### STAFF RECOMMENDATION

1116 Ordway Place

August 16, 2017

**Application:** New construction—outbuilding/detached accessory dwelling unit; Setback determination

SITE PLAN

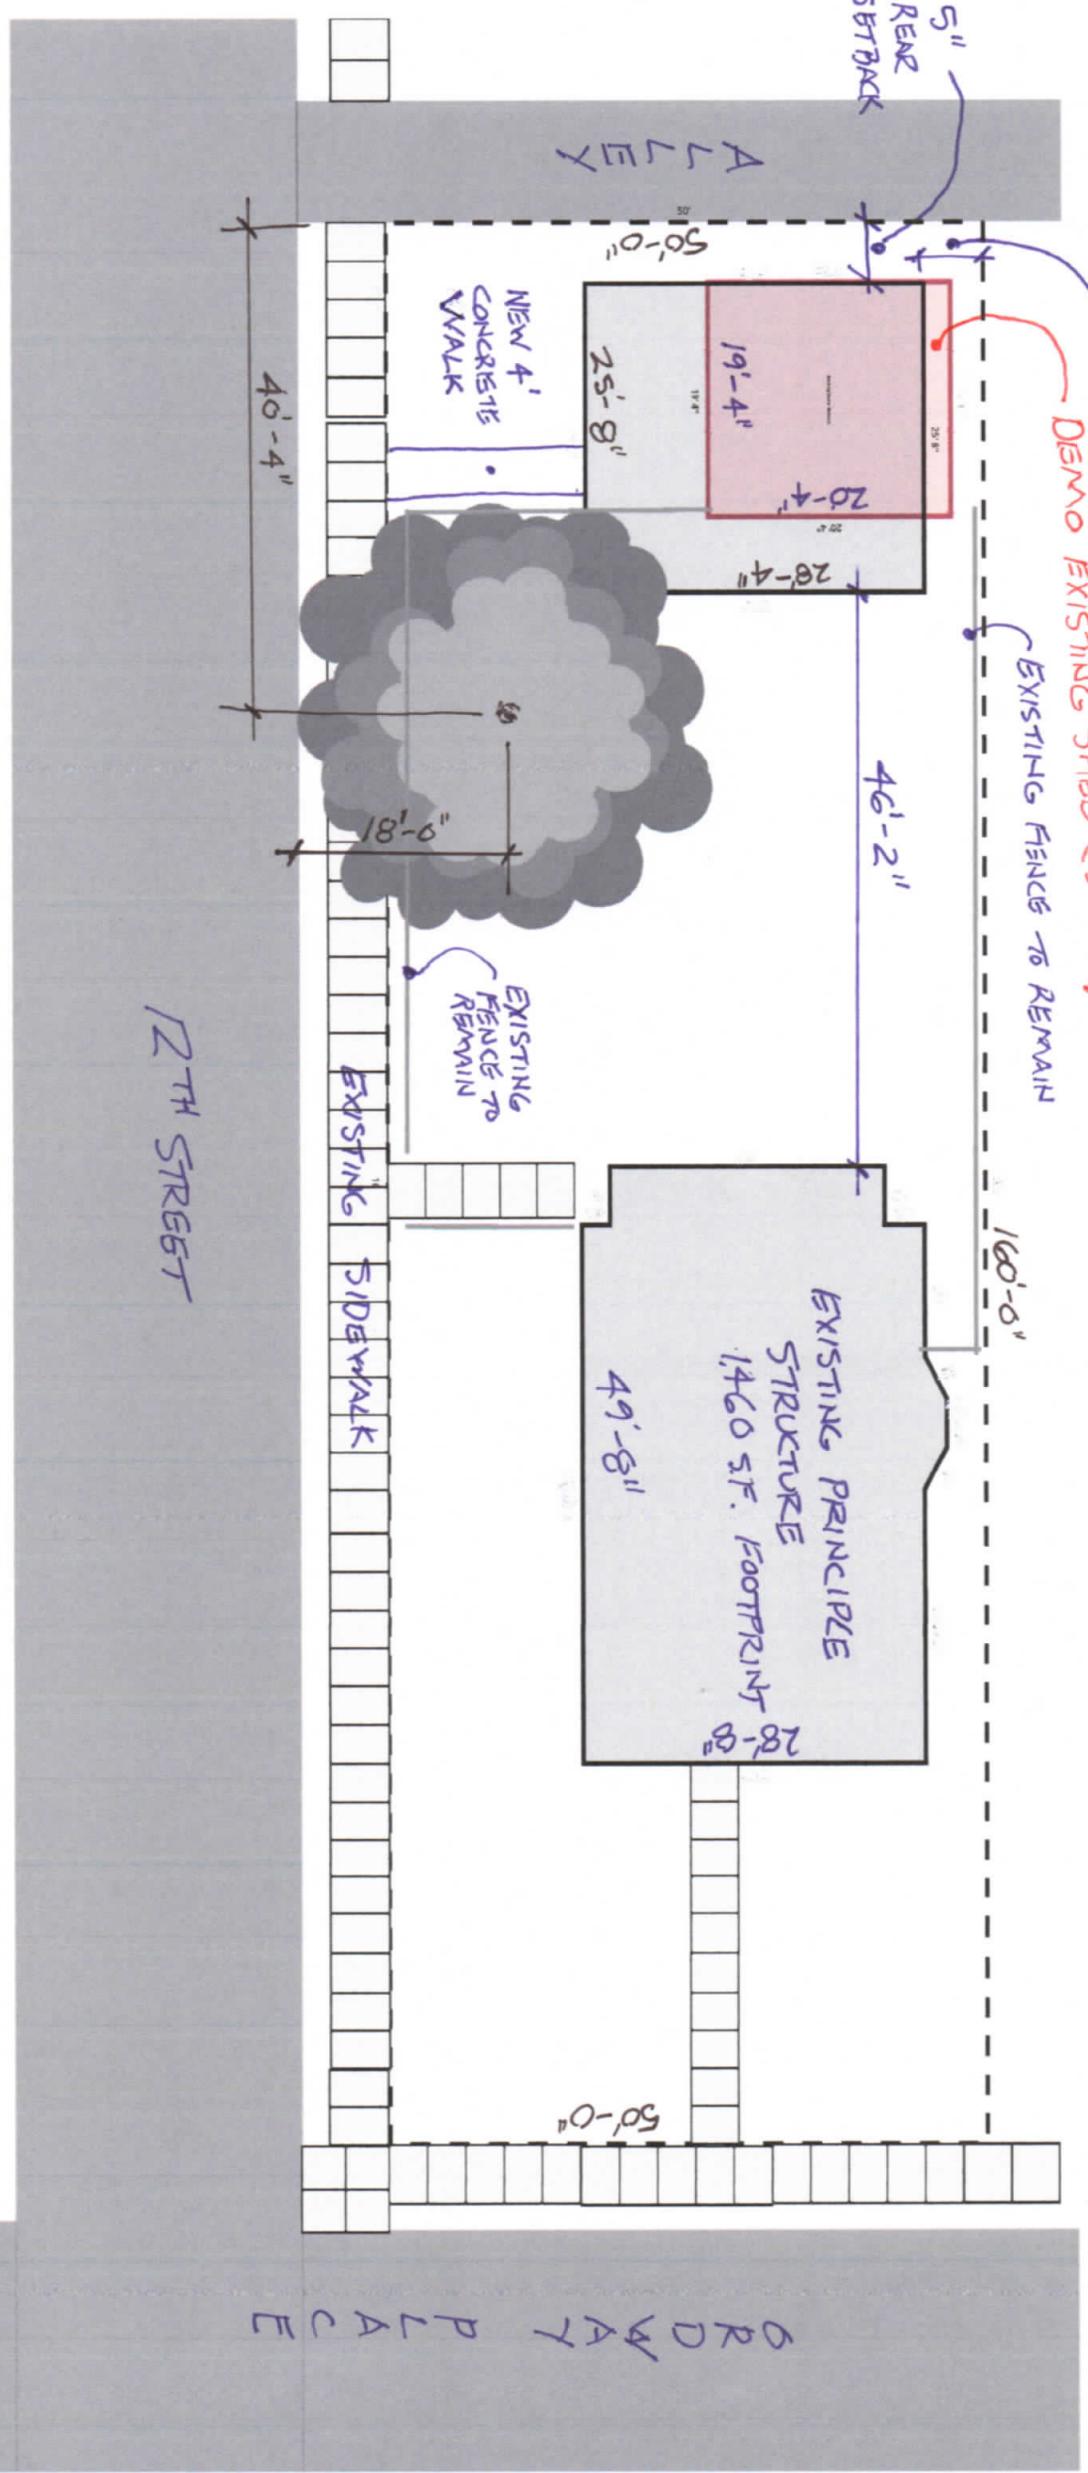
The proposed DADU meets all base zoning setbacks except for the rear setback. Staff finds that the proposed five feet (5') rear setback is appropriate since outbuildings were historically located closer to the rear property line. In addition, the proposed DADU does not include garage doors, so there is not a concern about maneuvering a vehicle into and from the alley. (The property currently does not include a driveway, and it appears that on-street parking is used.) In addition, the proposed DADU will have the same rear setback as the existing outbuilding that is to be demolished (Figure 2). For these reasons, staff recommends approval of the rear setback determination and finds that the proposed DADU meets section II.B.8.b of the design guidelines and 17.16.30.G. 4 of the ordinance.

FRONT ELEVATION - FACING 12<sup>TH</sup> STREET

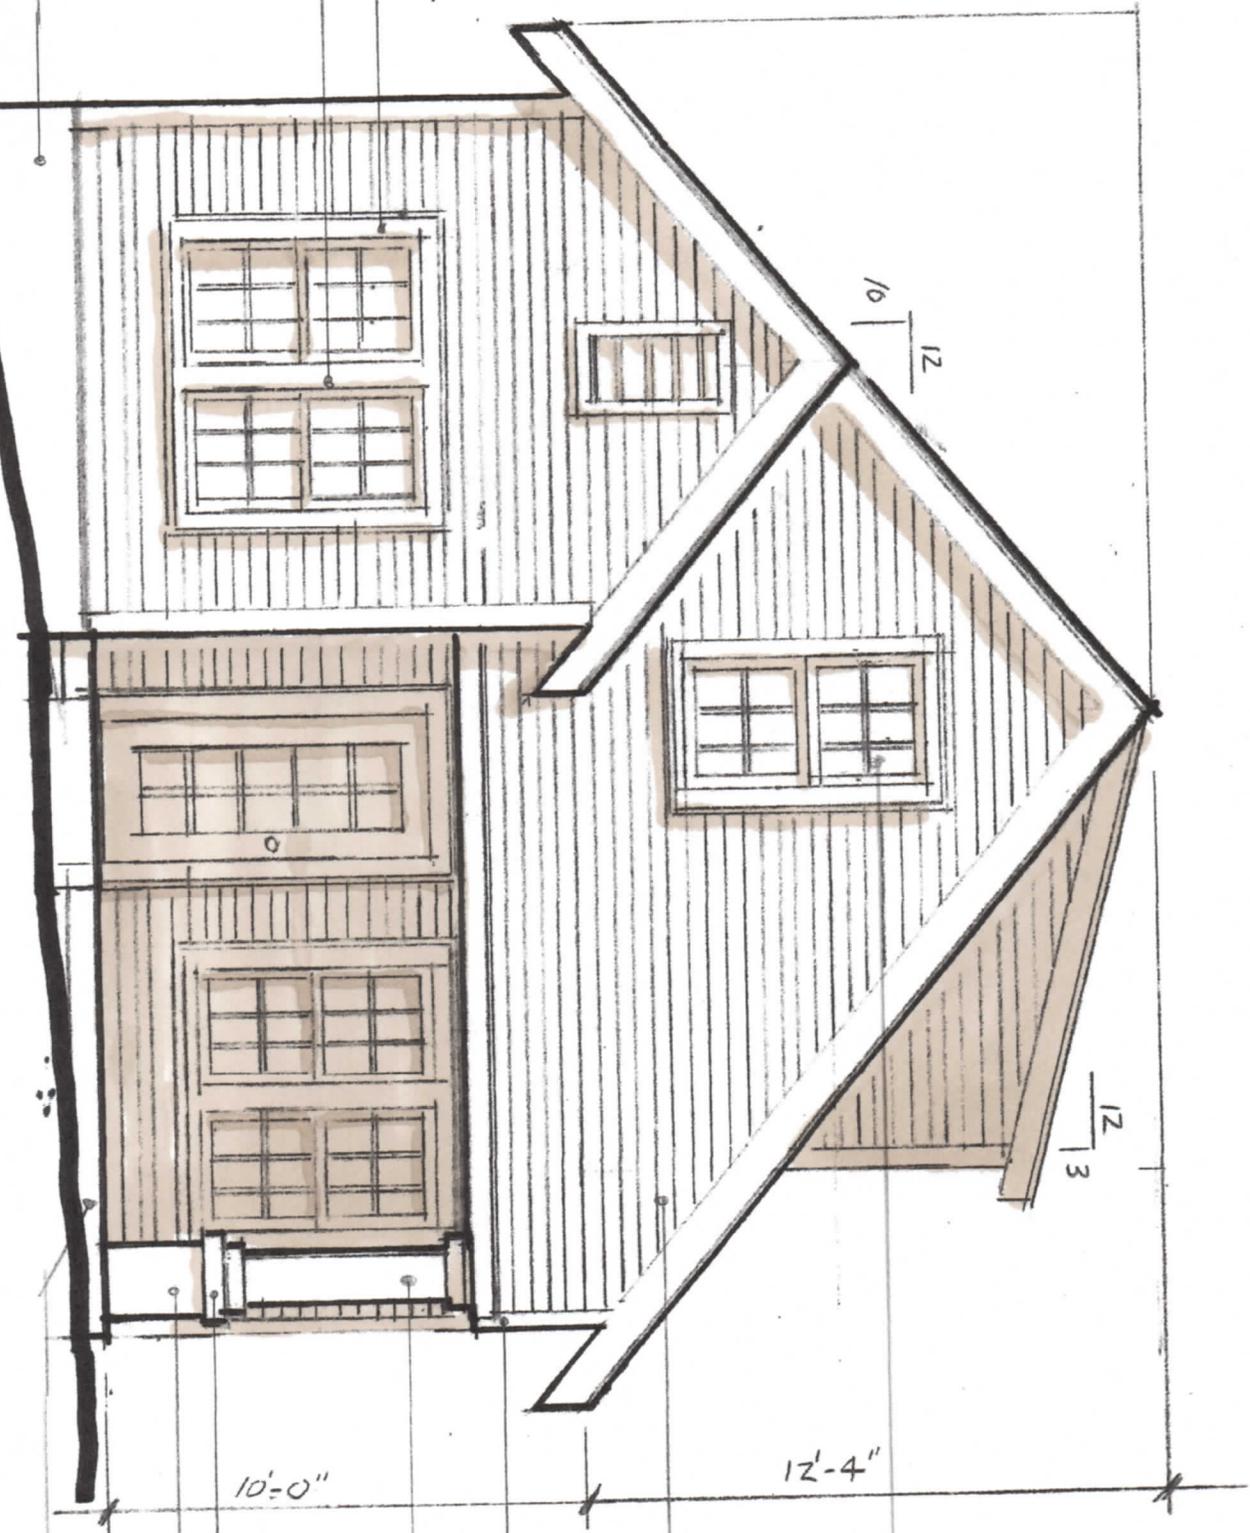
With the staff's final approval of the porch post material and the masonry color, dimensions and texture, staff finds that the known materials meet Section II.B.8.a. of the design guidelines.

1. The HVAC be located behind the house or on either side, beyond the mid-point of the house; and
2. Staff approve the porch post material and the masonry color, dimensions and texture for the front porch cap and base.
